EPC STORMWATER REVIEW COMMENTS
IN ORANGE BOXES WITH BLACK TEXT

Landscape Endeavors Building Addition

Commercial Construction Drawings

Landscape Endeavors Building Addition
CES Endeavors, LLC
Civil Site Plan
El Paso County, Colorado

SF	STORMWATER ENTERPRISE	SILT FENCE		
		ISSUED: 10/7/19	REVISED: 8/19/2020	DRAWING NO: 900-SF

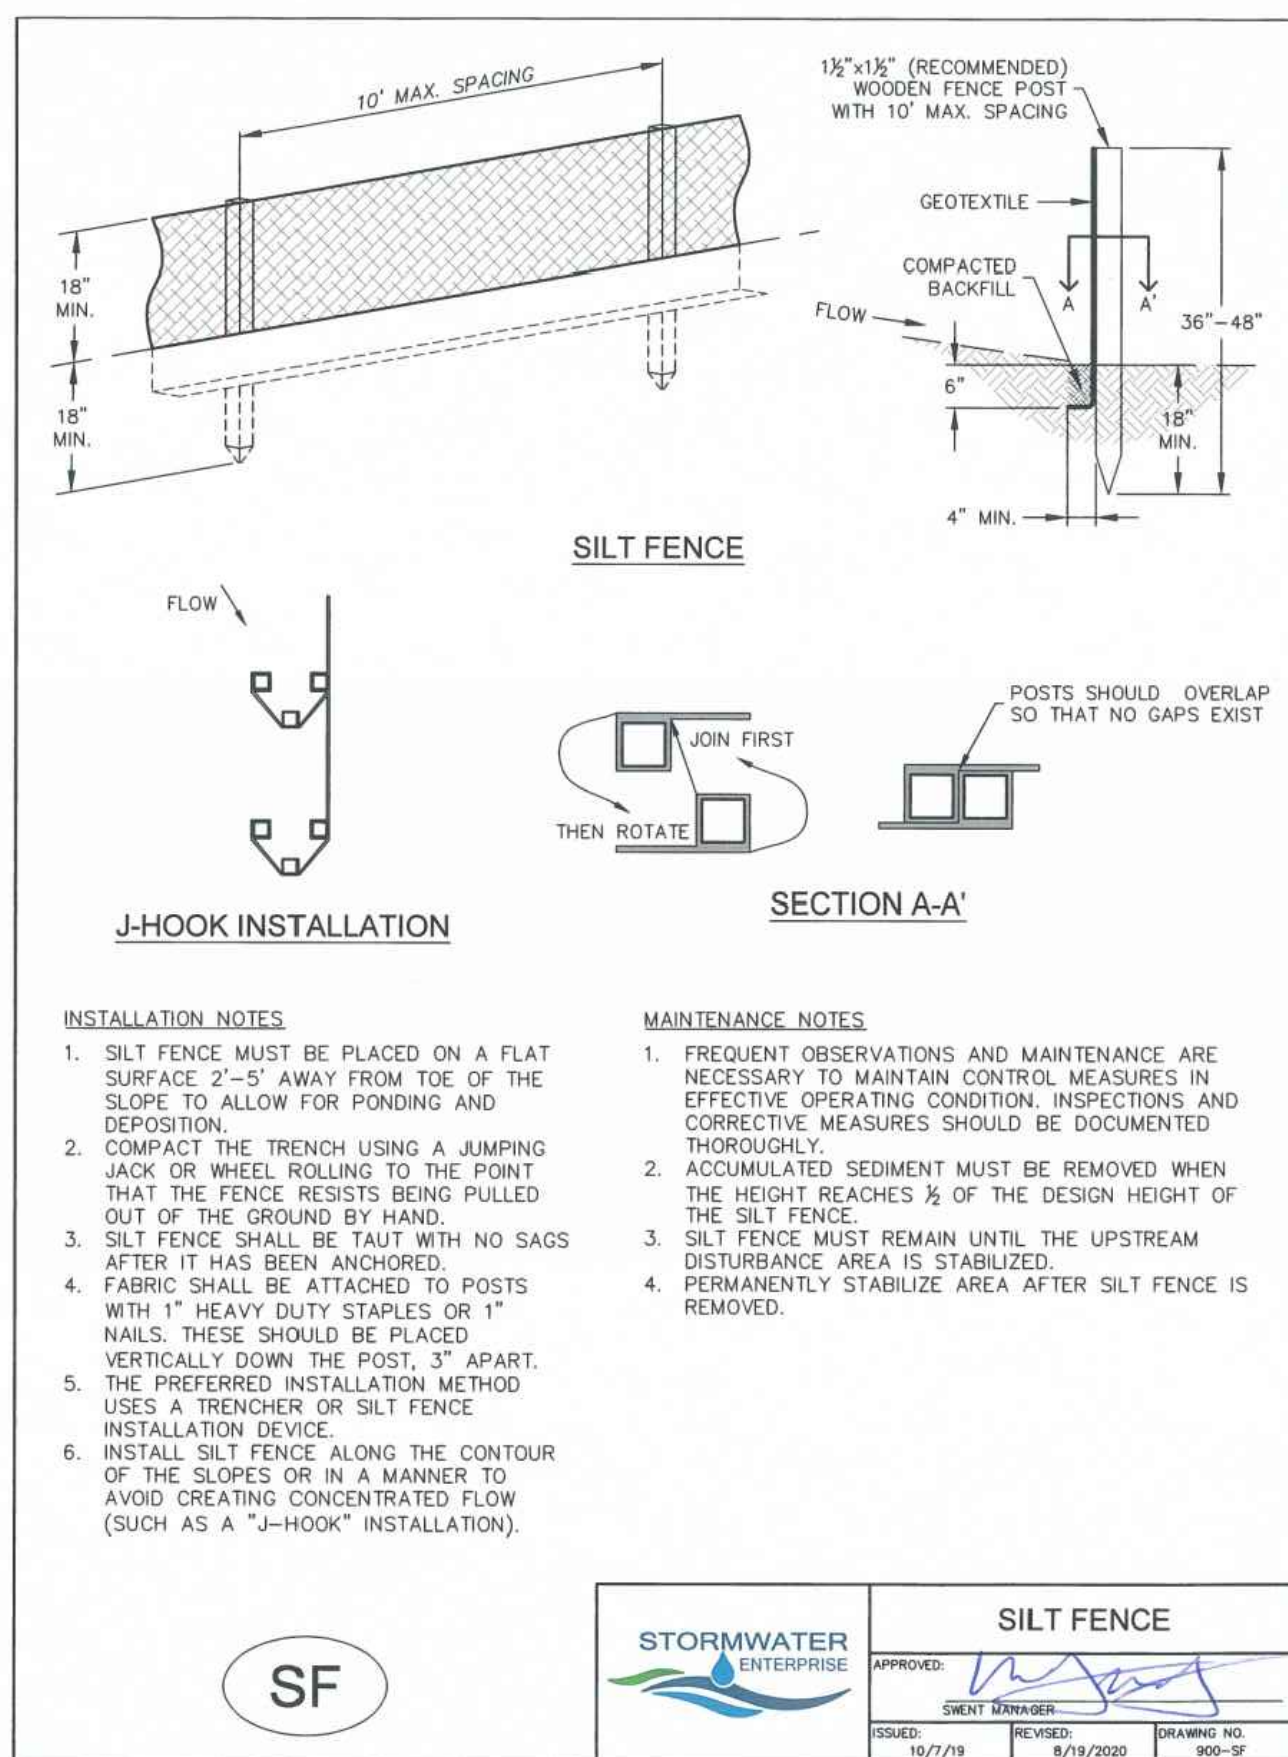
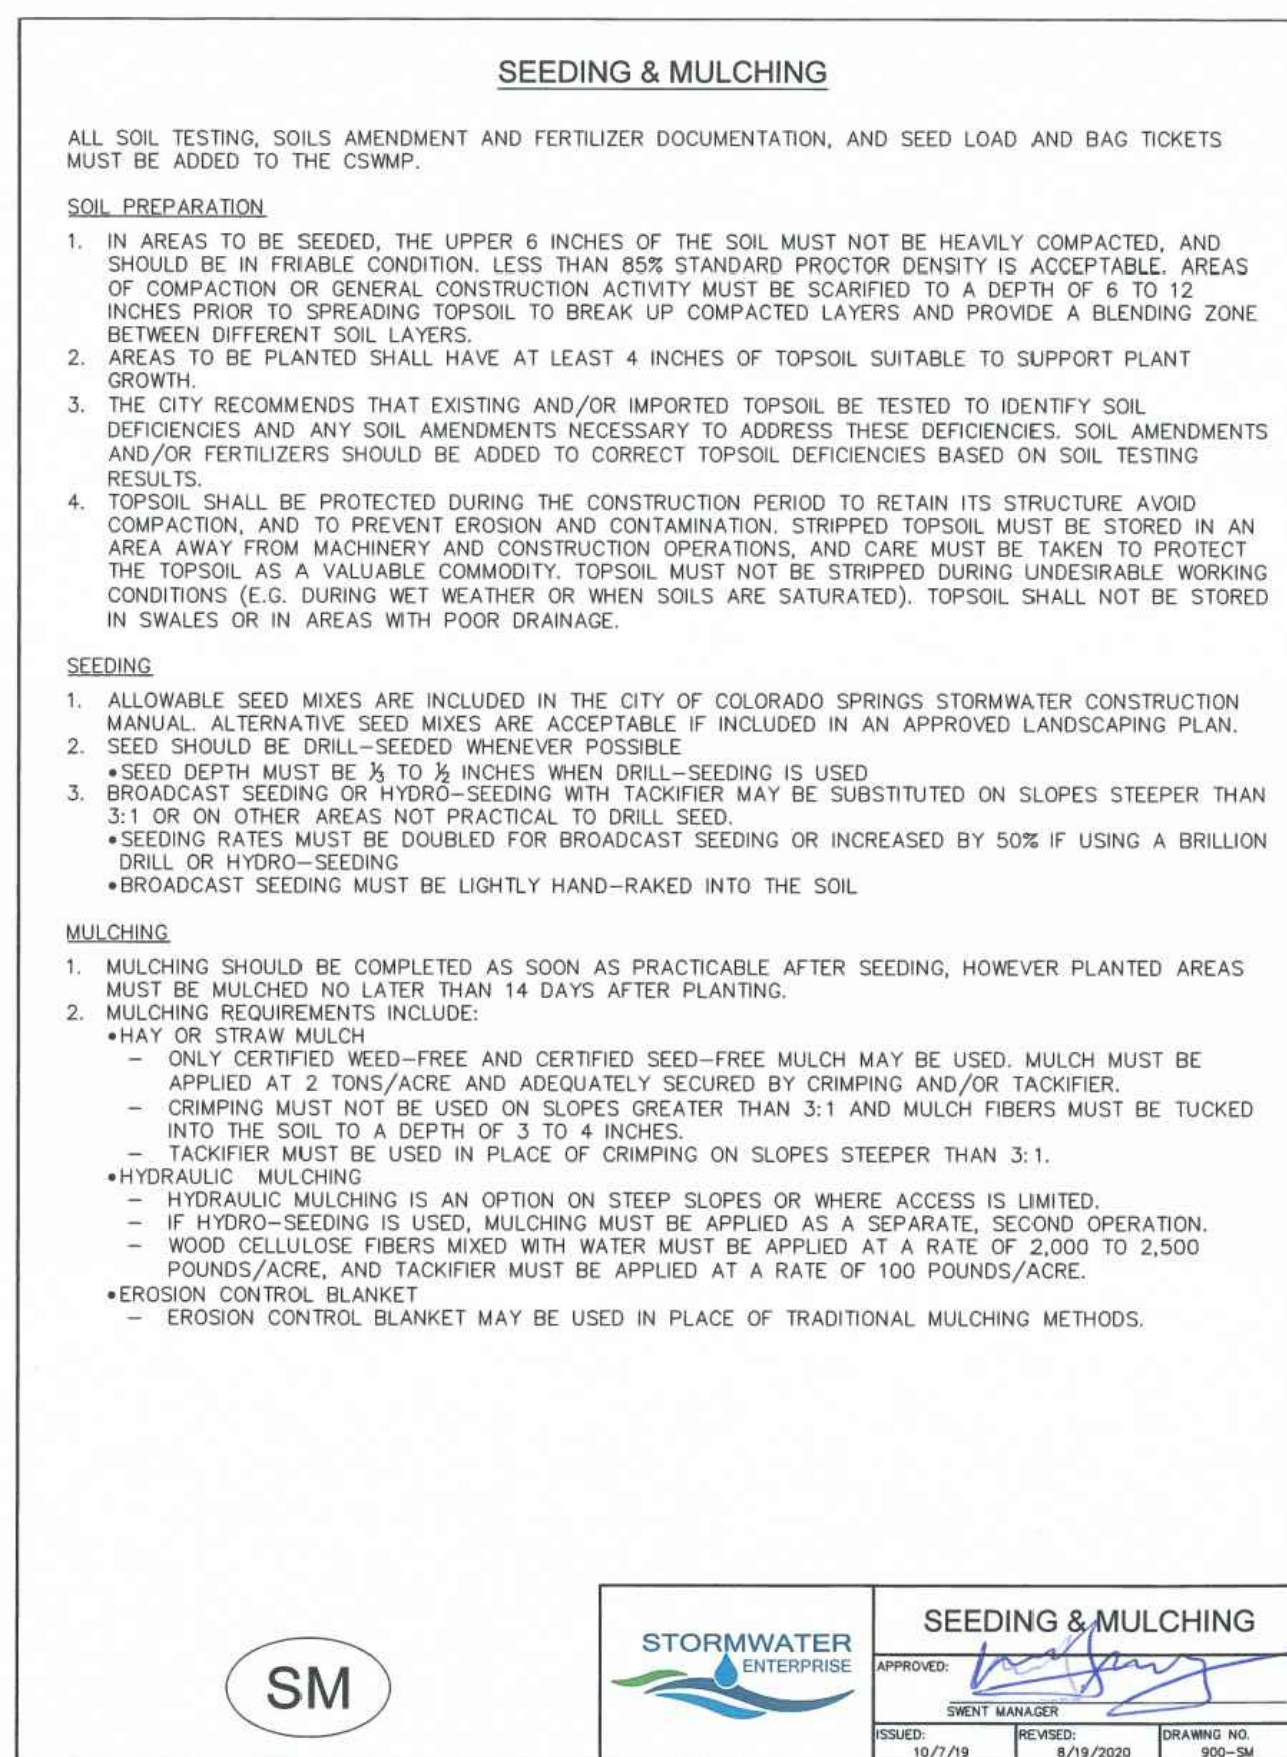
SWMP Checklist Item 20 - Include details for: sediment control log, inlet protection, and stockpile management.

ISSUED: 10/7/19 REVISION: 8/19/2020 DRAWING NO. 900-VTC

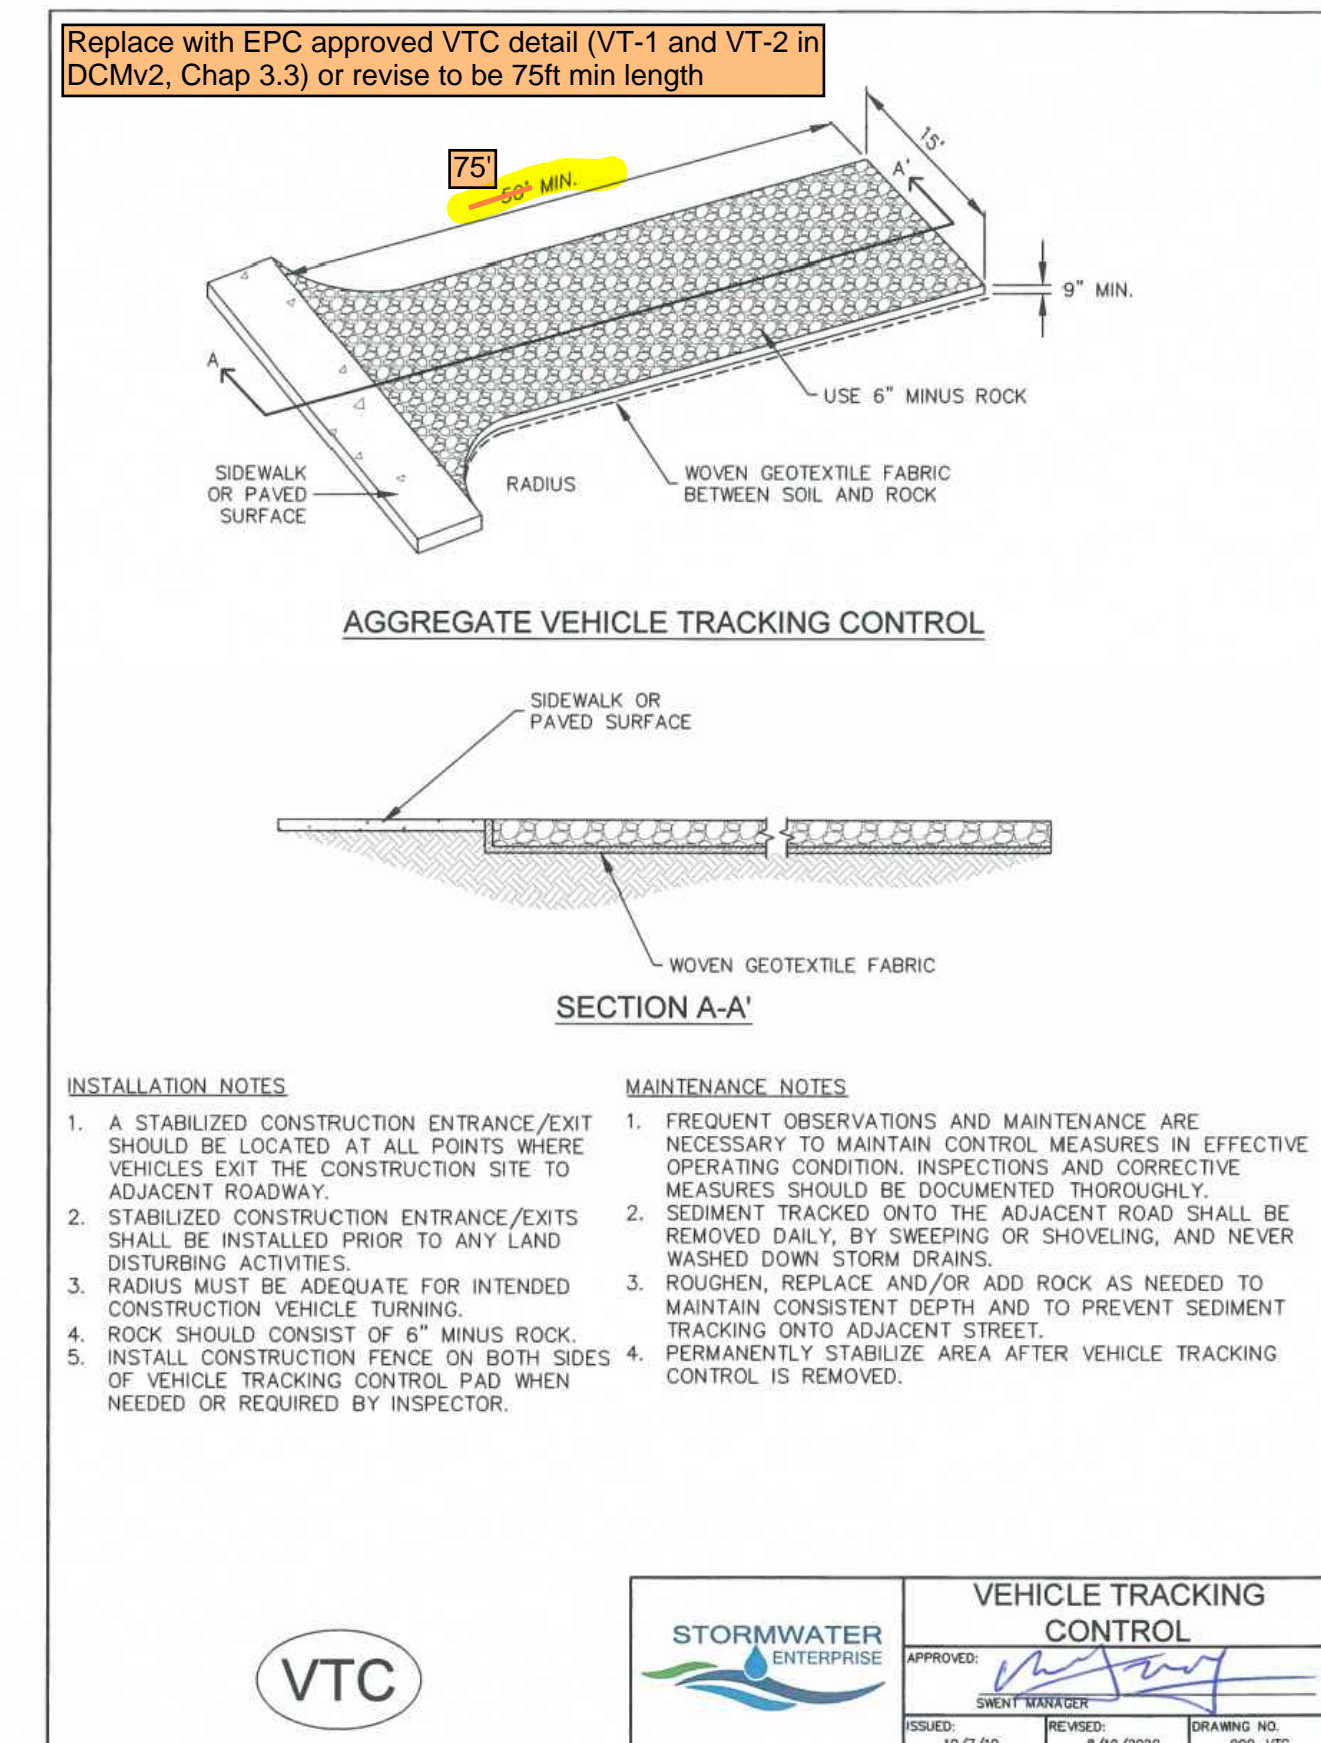
Replace with EPC approved VTC detail (VT-1 and VT-2 in DCMv2, Chap 3.3) or revise to be 75ft min length
